Buncombe County Planning Board April 20, 2015

SUB2015-00078: Drew Norwood of Windsor Built Homes, Inc. was seeking preliminary approval of Glen Bridge Road Subdivision, which is located at 925 Glen Bridge Road SE (PIN 9634-63-4032).

Buncombe County Planning Board Meeting Recommended Staff Conditions SUB2015-00078 April 20, 2016 Glenn Bridge Subdivision

Buncombe County Planning Board Meeting Recommended Staff Conditions **SUB2015-00079** April 20, 2016 **The Ramble Block E**

sheet <u>C-100</u>

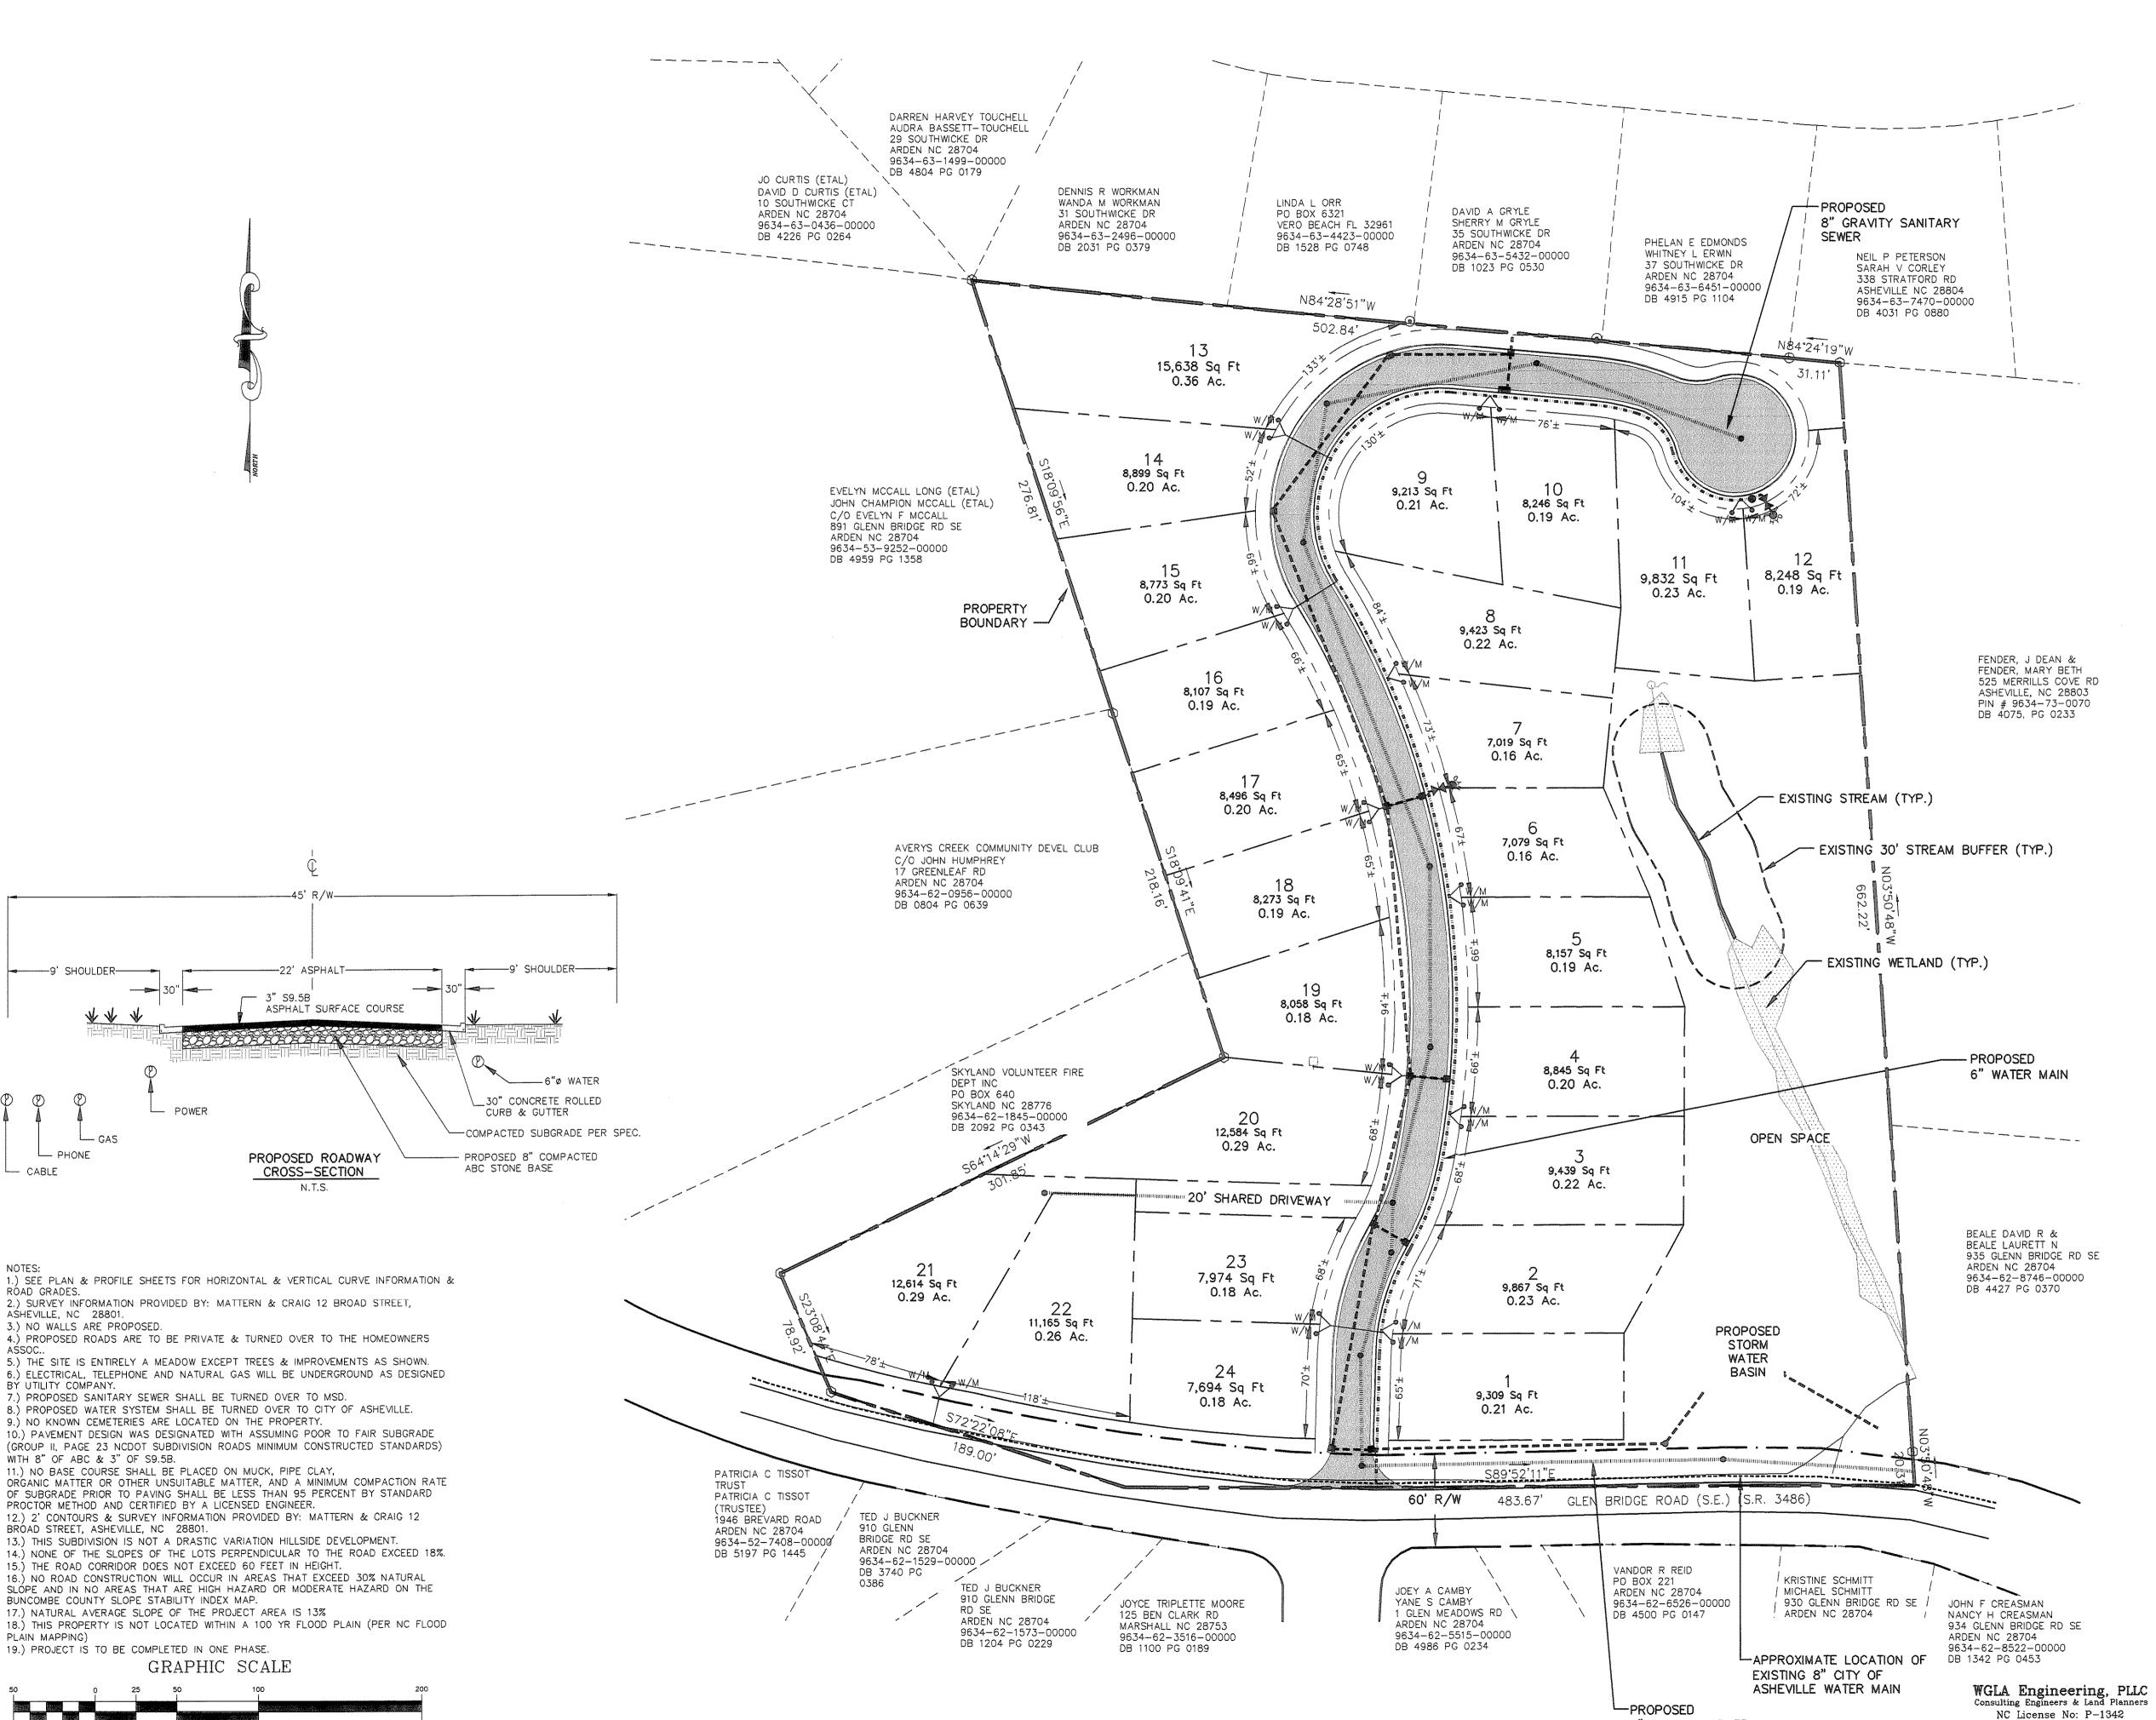
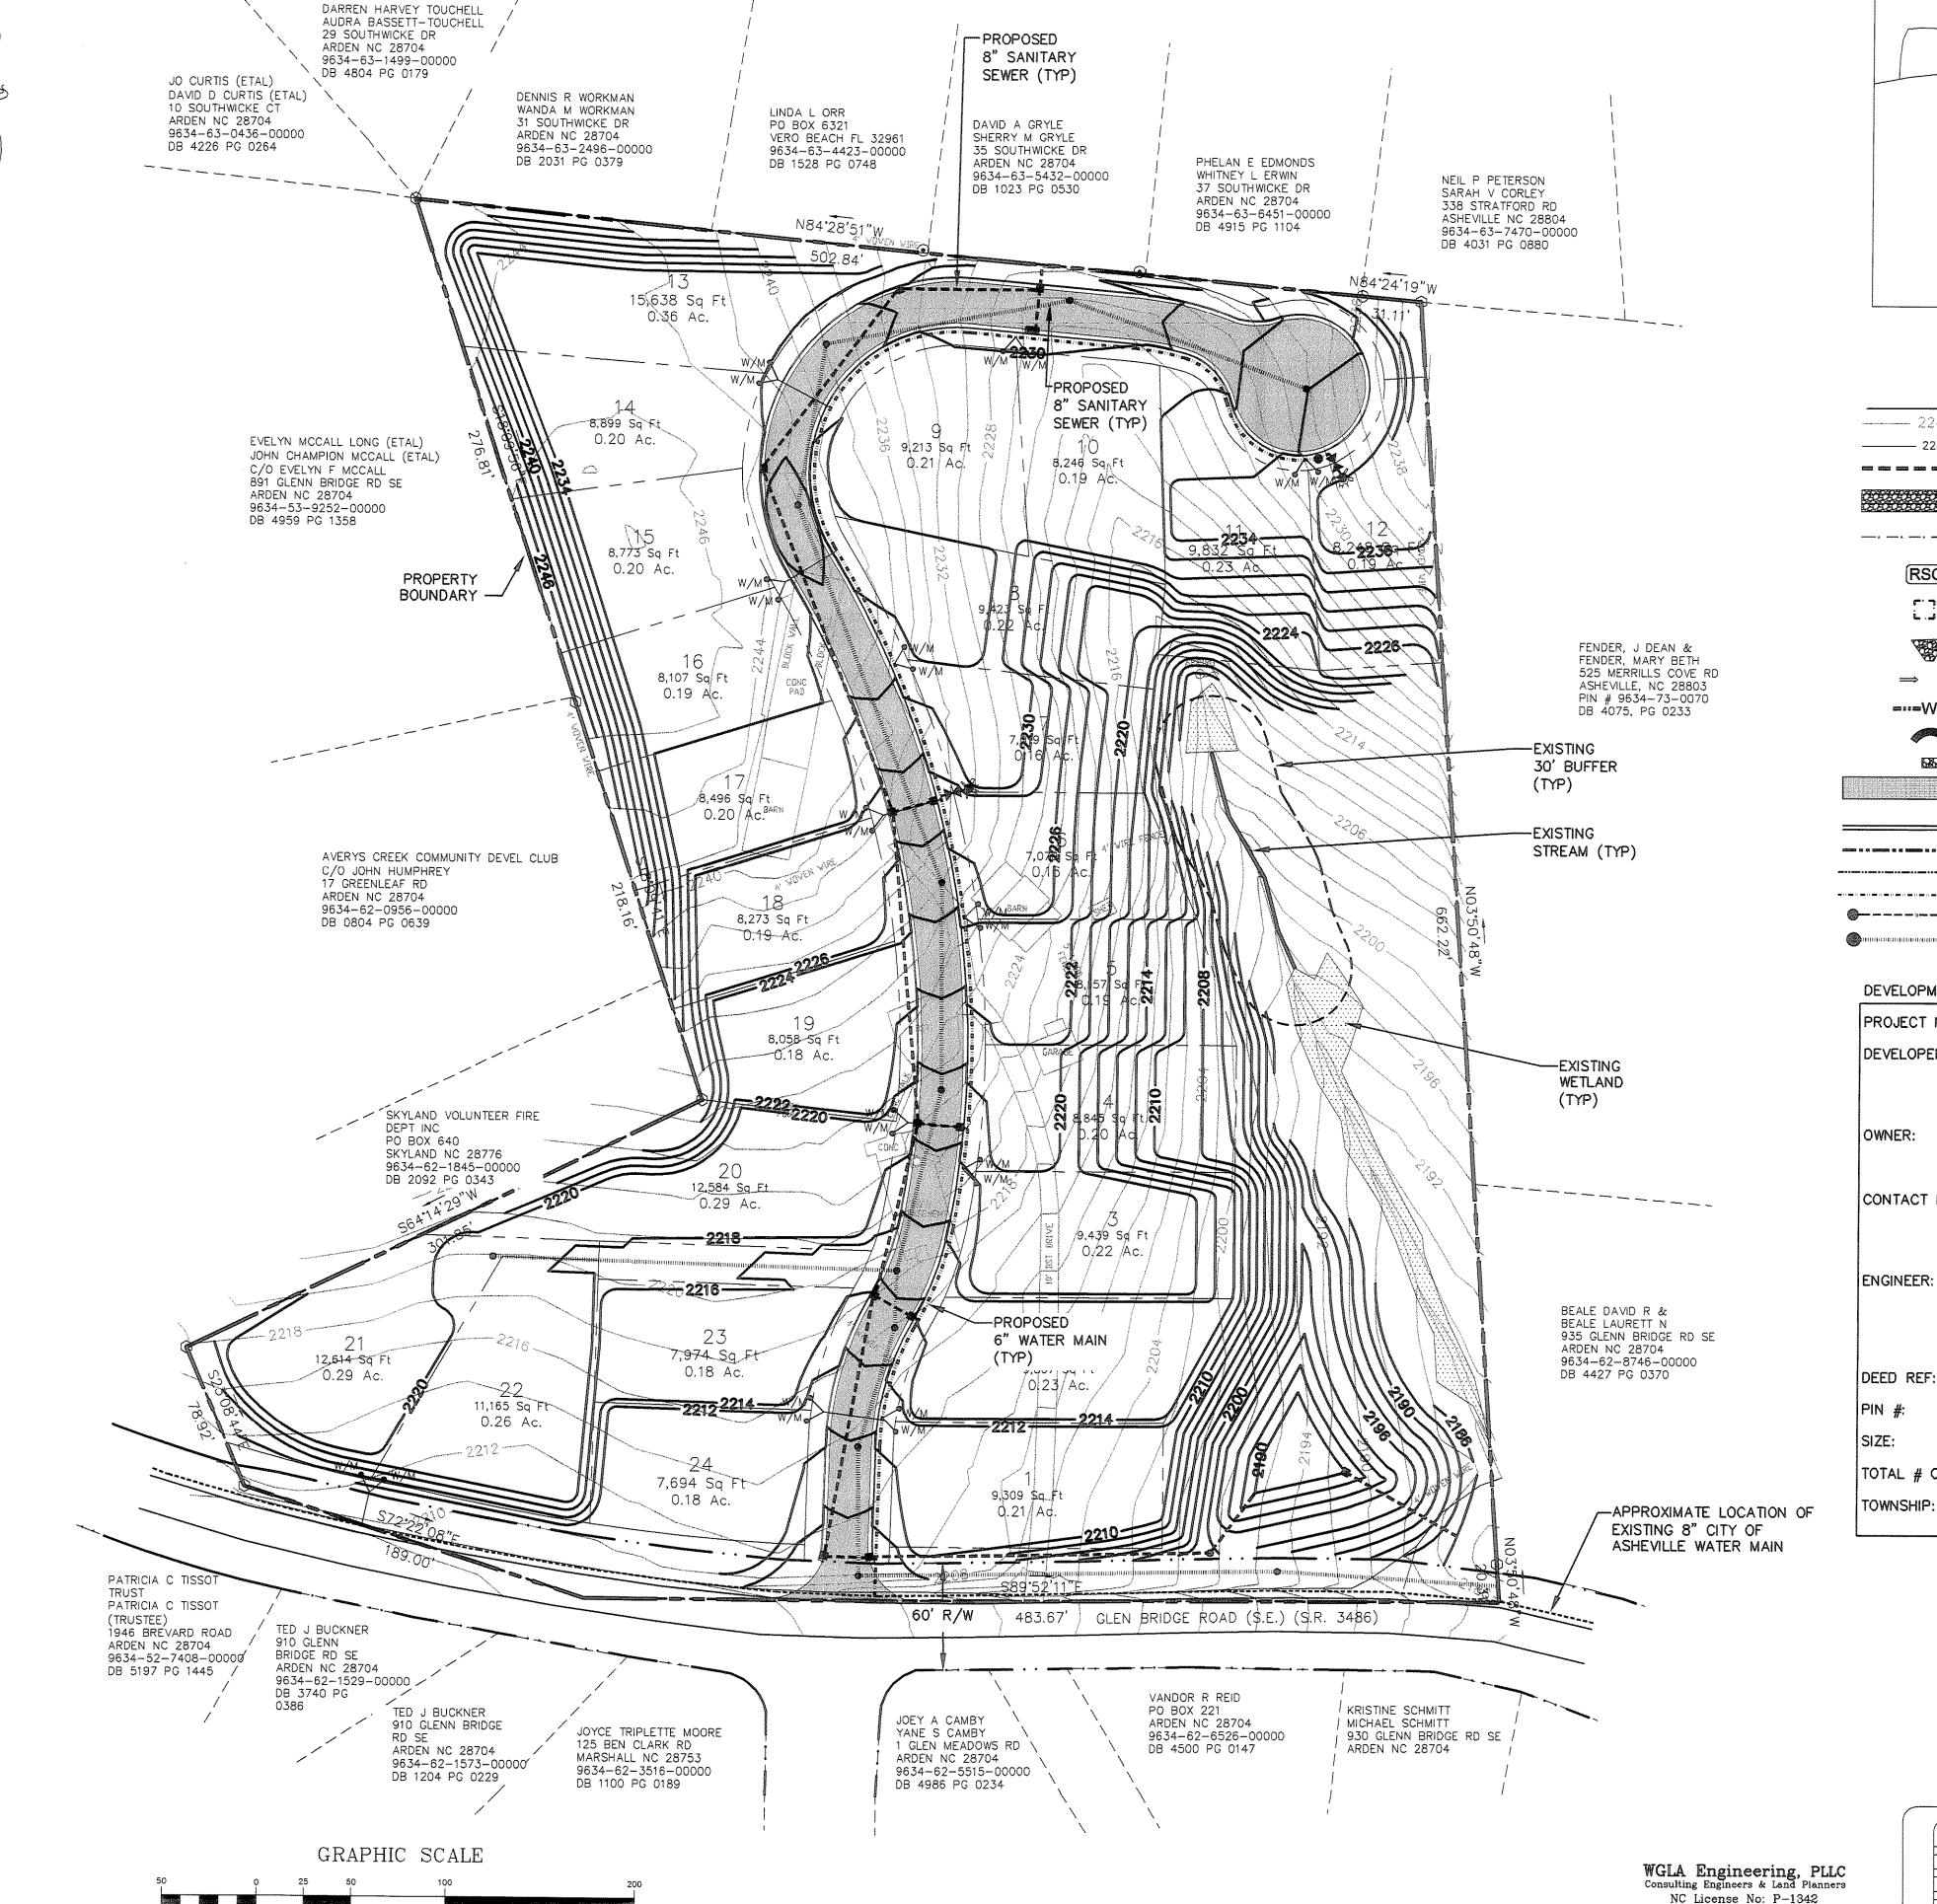
The plans were granted preliminary approval at the 4/20/2015 meeting with the following conditions: Provide proof of approval of road names and addresses from E-911 Addressing.

Provide proof of approval from the Buncombe County Erosion Control Officer that an Erosion Control Plan has been submitted and approved for the project. No grading shall occur on the site until an approved Buncombe County Erosion Control permit is obtained.

3. Provide proof of approval from the Buncombe County Stormwater Administrator that a stormwater management plan has been submitted and approved for the project. No grading shall occur on the site until an approved Buncombe County Stormwater permit is obtained.

4. Provide proof of approval of system design for City of Asheville Water lines. Proof of acceptance of the water lines into the City of Asheville's water system or an engineer's certification that the system has been installed to City of Asheville's standards will be required prior to recordation of a final plat or release of a

Provide proof of approval of system design from the Metropolitan Sewerage District. Proof of acceptance of the sewer lines into the Metropolitan Sewerage District sewage system or an engineer's certification indicating that the system has been installed to MSD standards will be required prior to recordation of a final plat or release of a financial guarantee.

Provide a copy of the approved NCDOT driveway permit.

Indicate on the submitted plans that the shared driveway is less than 20% grade.

Indicate the existing us of the land abutting the subdivision.
